| Illinois Tollway Standard Drawing Revisions |

| Section E | Maintenance of Traffic |                                                                                                                                                                                                                                                                     |                       |
|           | Standard               | Modification Summary                                                                                                                                                                                                                                                | Effective: 03-01-2025 |

APPROVED BY: *Manar Nashif*  
CHIEF ENGINEERING OFFICER

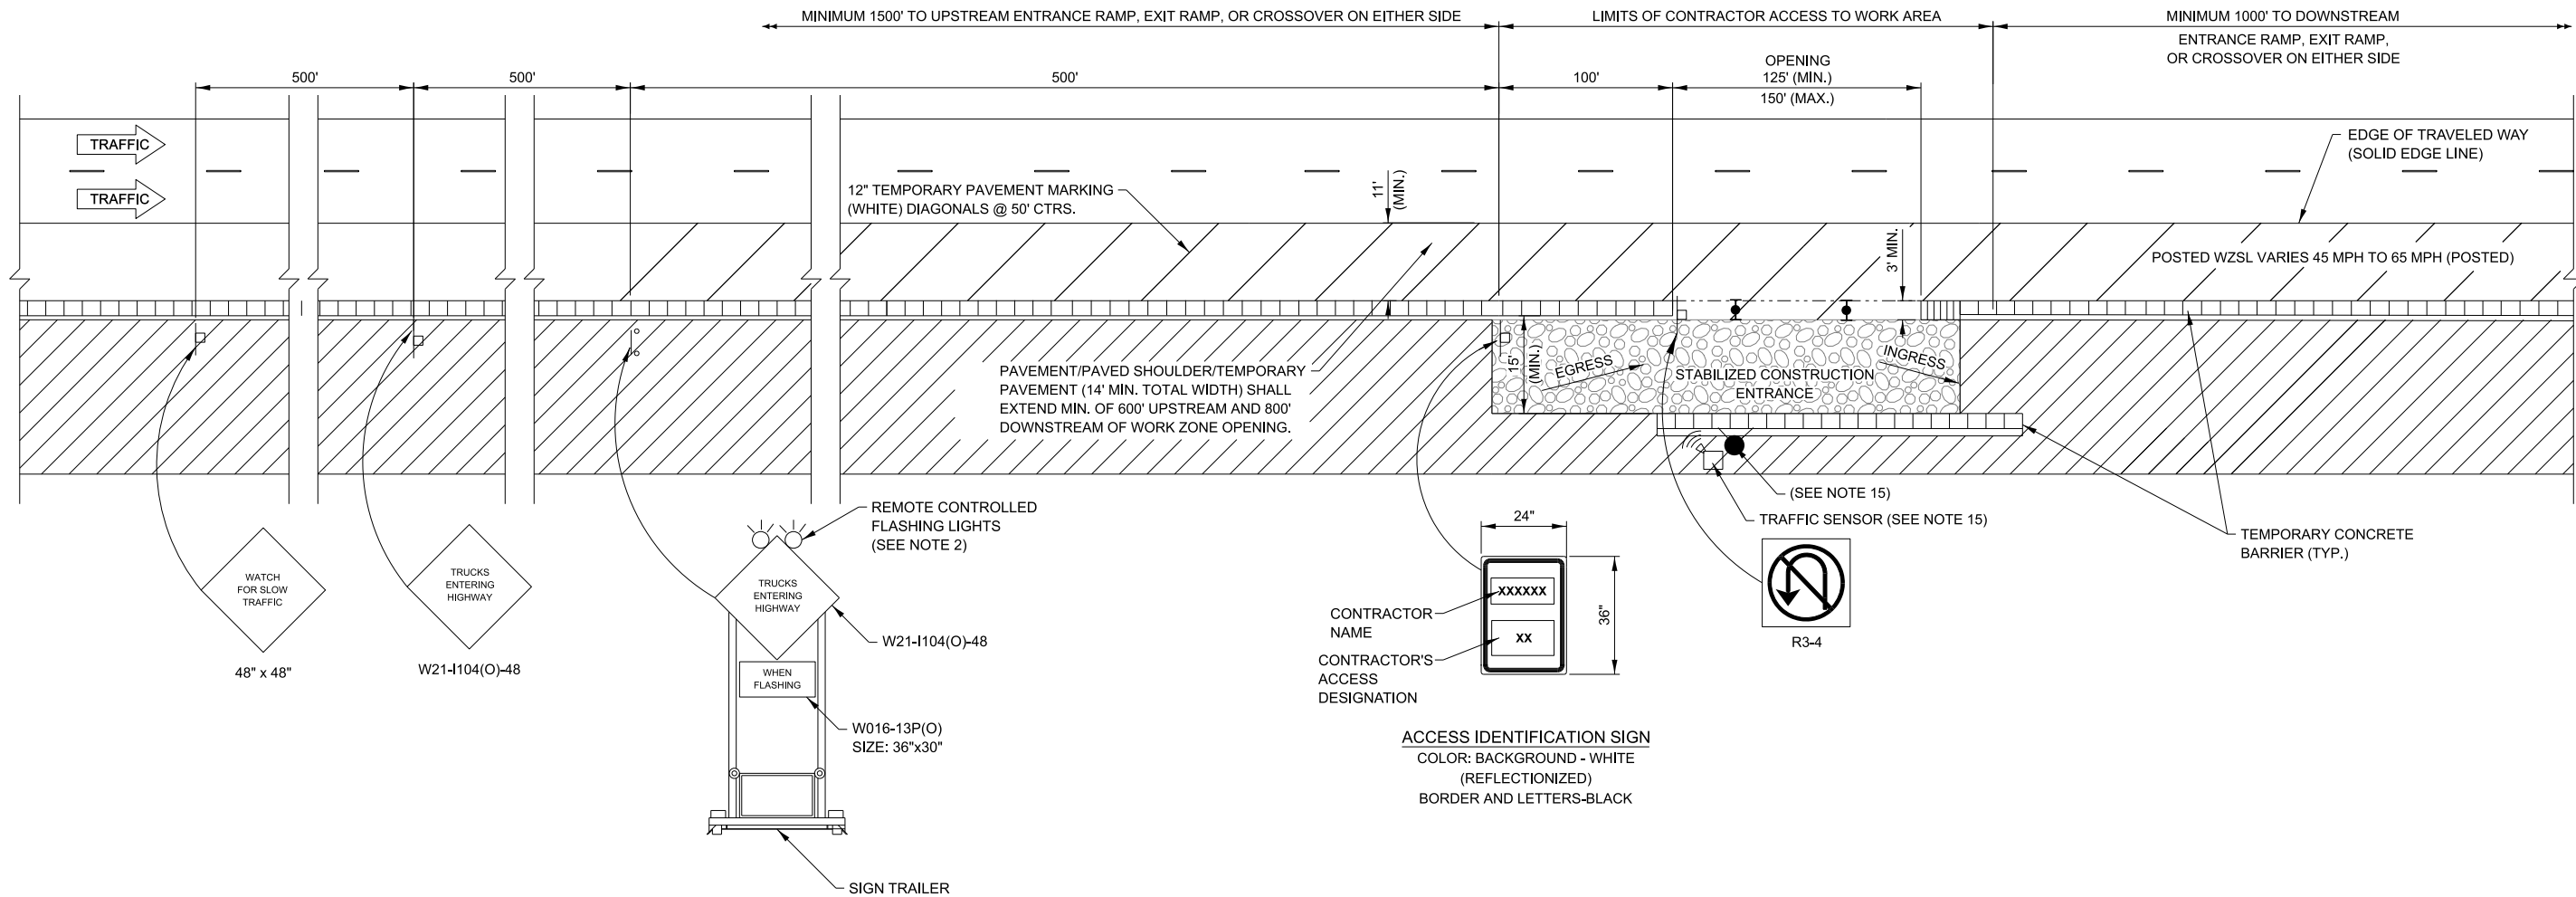
| Section E | Maintenance of Traffic |                                                                                                                                                                                                                                                                     |                       |
|-----------|------------------------|---------------------------------------------------------------------------------------------------------------------------------------------------------------------------------------------------------------------------------------------------------------------|-----------------------|
|           | Sheets 1 & 2           | Revised work area hatching to increase buffer to active lane                                                                                                                                                                                                        |                       |

| DATE       | DESCRIPTION                                                                                |
|------------|--------------------------------------------------------------------------------------------|
| 03-01-2025 | REDUCED WORK AREA TO PROVIDE 3 FT<br>BUFFER TO ACTIVE LANES                                |

CONTRACTOR ACCESS TO WORK AREA

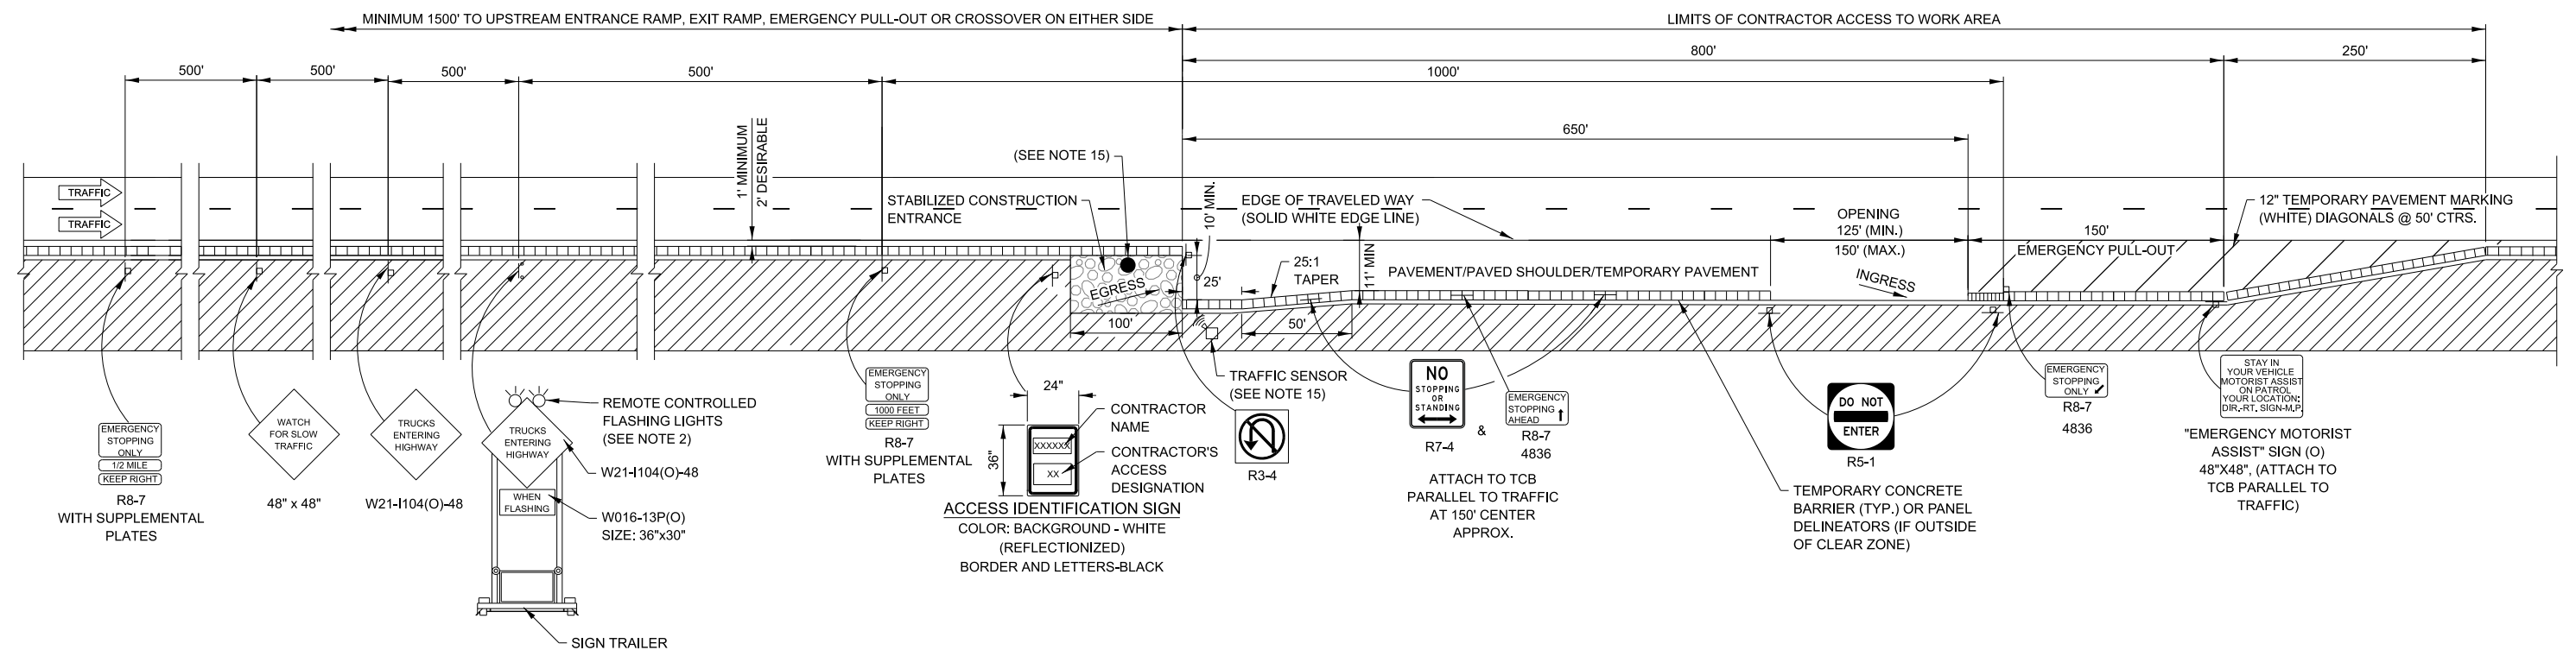
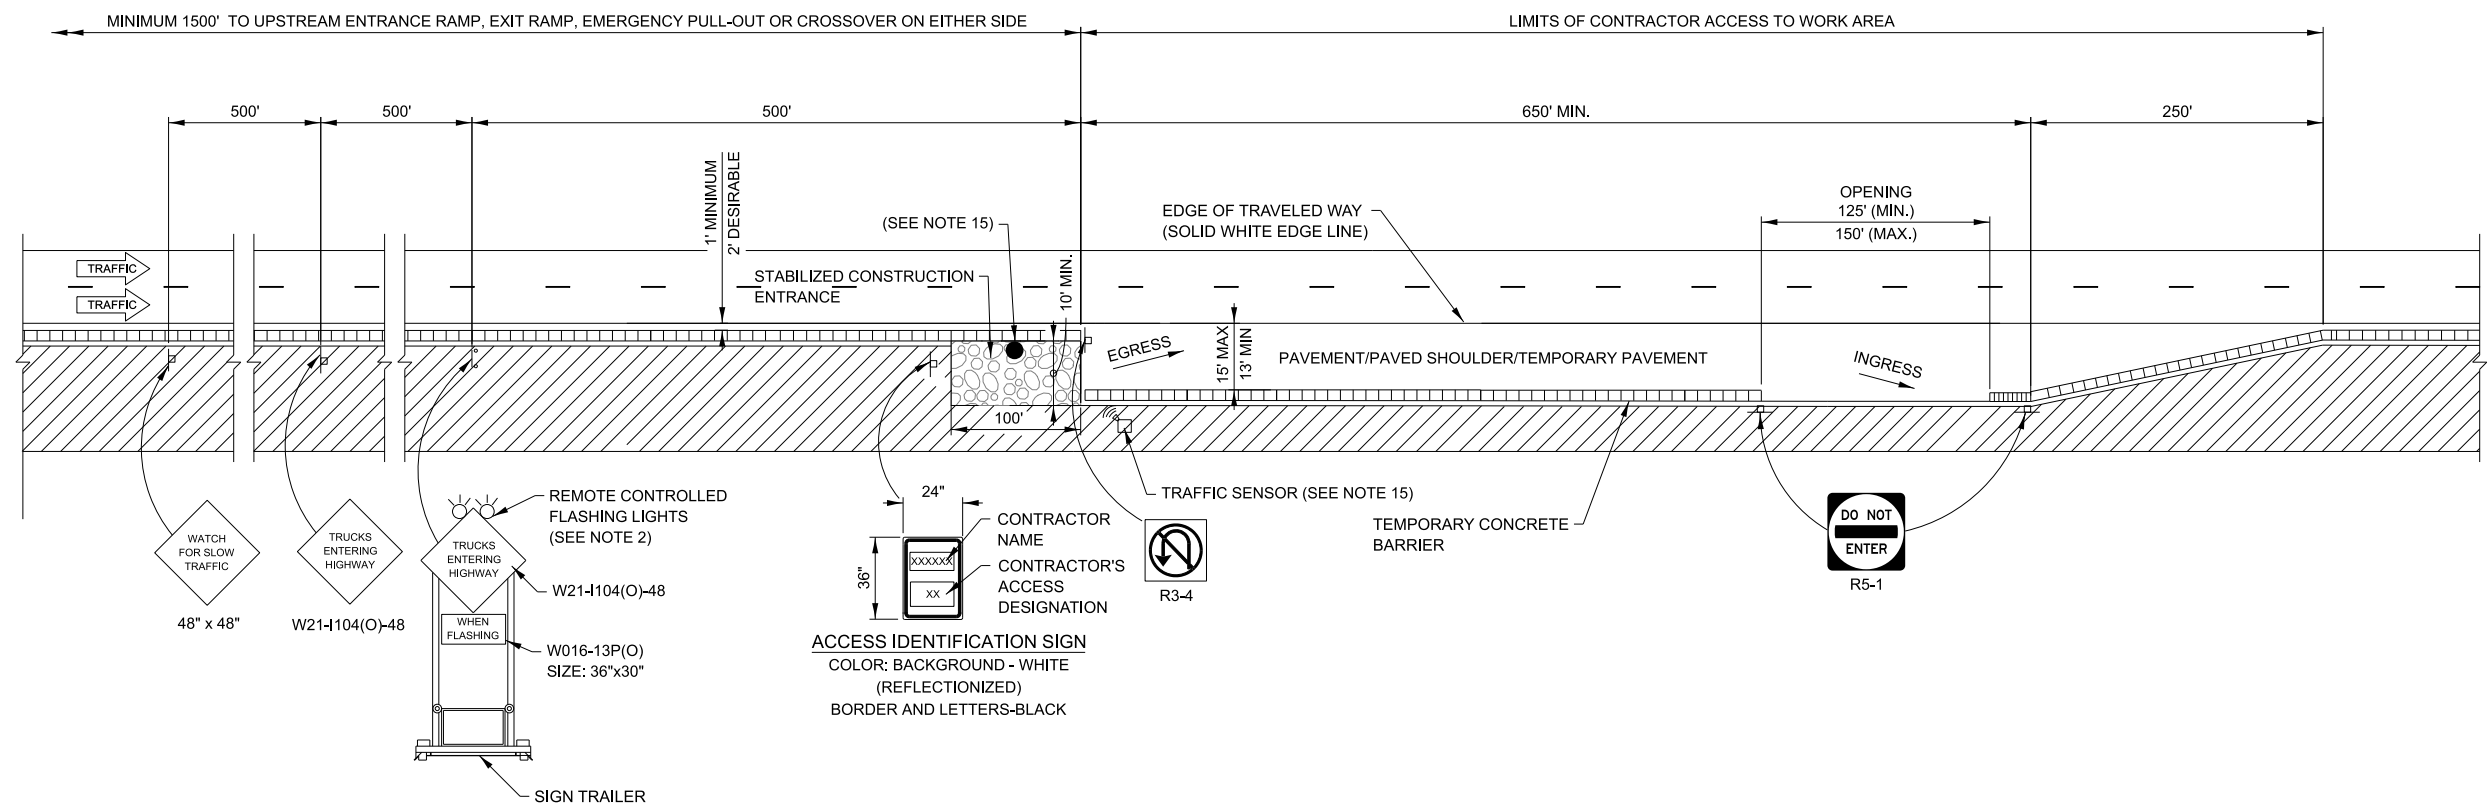
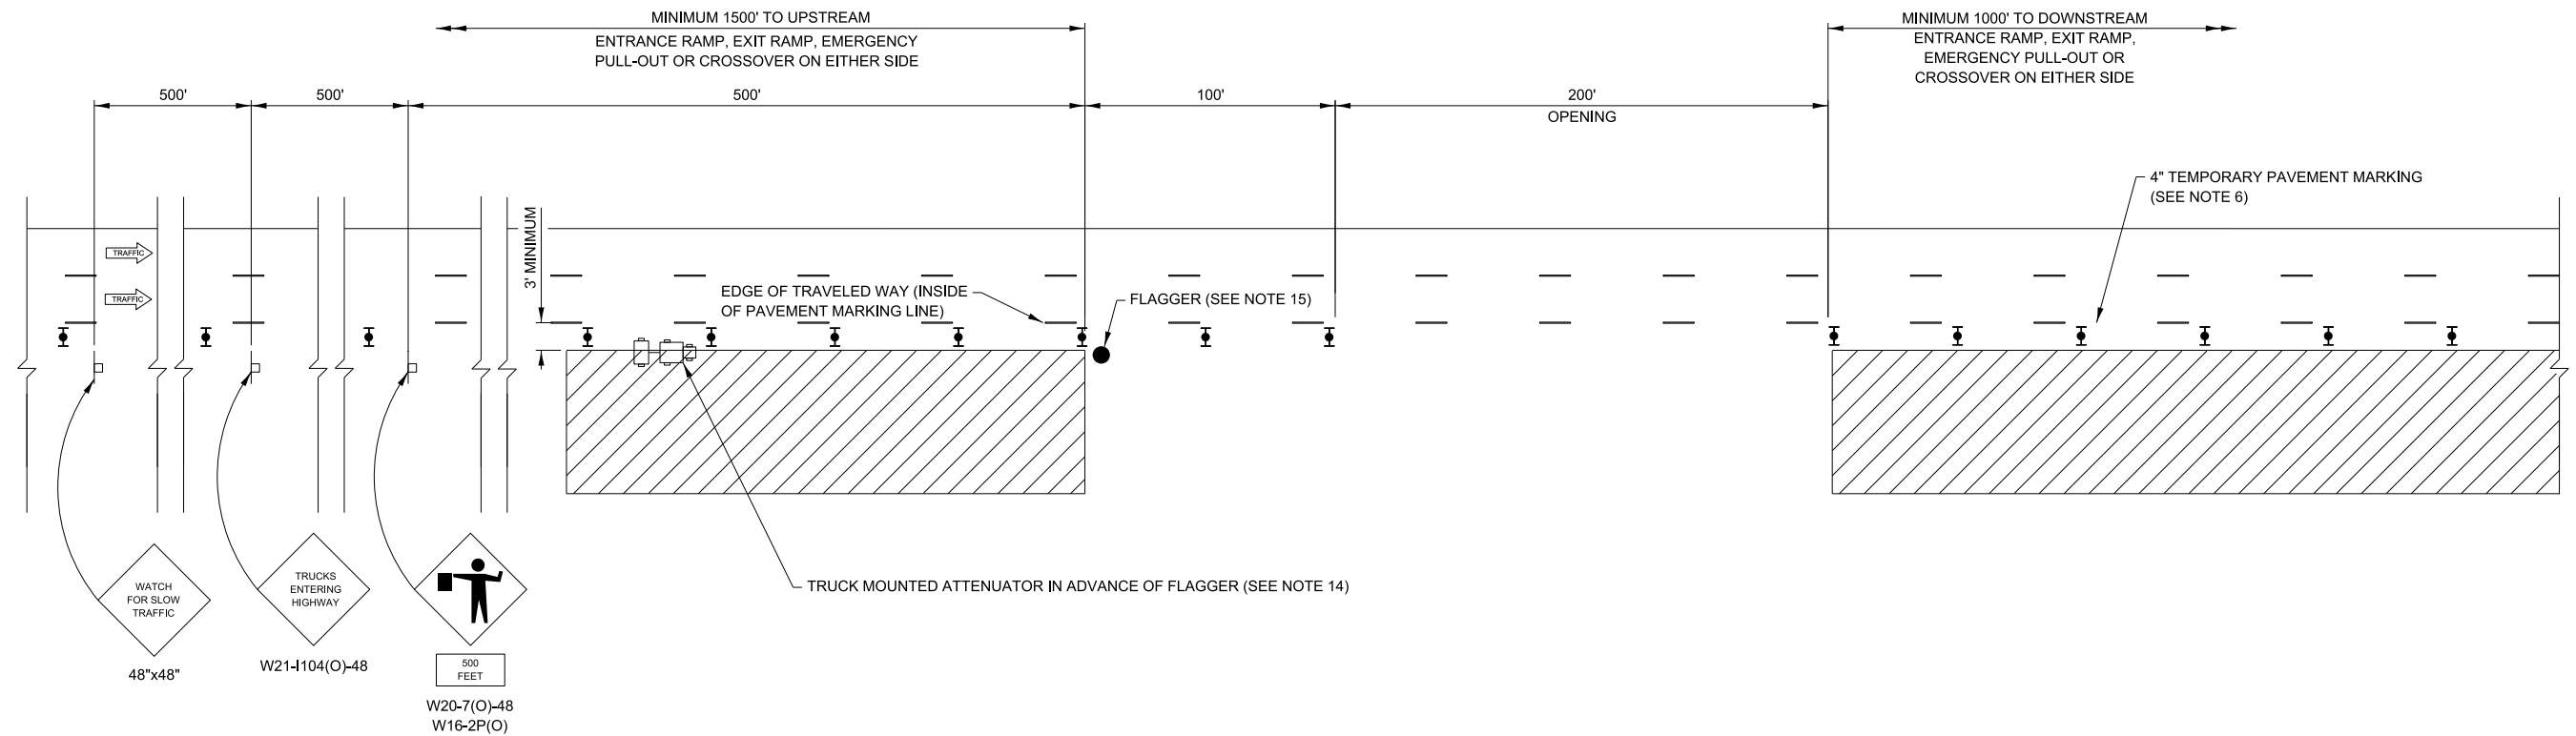
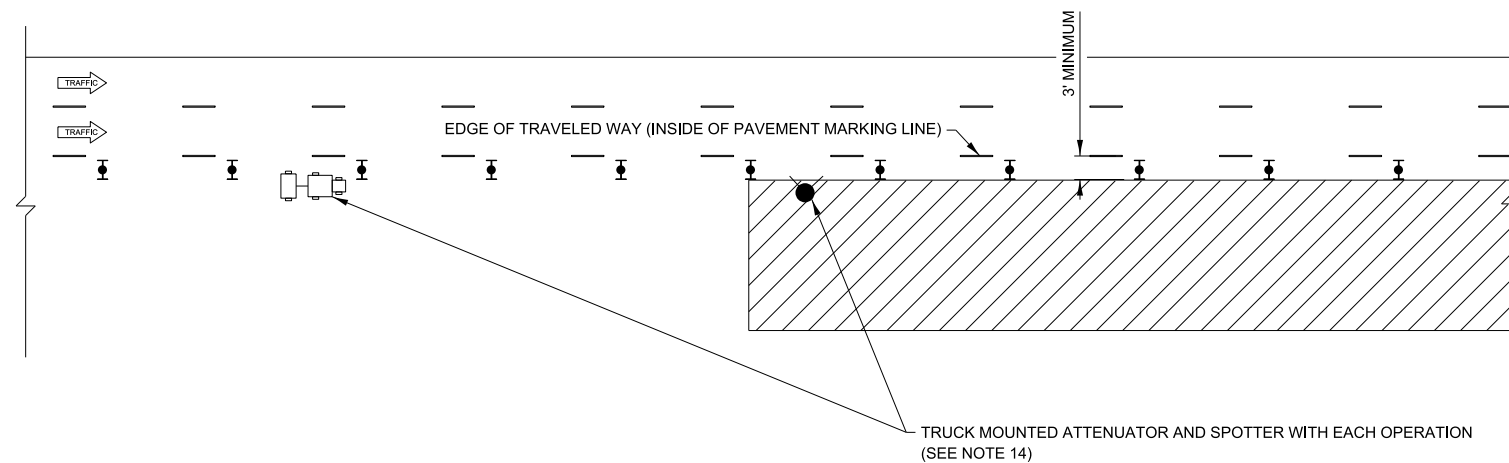
| Section E | Maintenance of Traffic |                                                                                                                                                                                                                                                                     |                       |
|-----------|------------------------|---------------------------------------------------------------------------------------------------------------------------------------------------------------------------------------------------------------------------------------------------------------------|-----------------------|
|           | Sheet 1                | Various notes revised and revised Contractor Access to Work Area design to include full shoulder and named it as Type A.                                                                                                                                            |                       |
|           | Sheet 2                | Included new designs for Contractor Access Type B and Type C.                                                                                                                                                                                                       |                       |
|           | Sheet 3                | Added callout for Note 15 to the flagger in Construction Access w/o Barrier Wall detail.                                                                                                                                                                            |                       |

| REVISIONS  |                                                           |
|------------|-----------------------------------------------------------|
| 03-01-2025 | REDESIGNED CONSTRUCTION ENTRANCES                         |
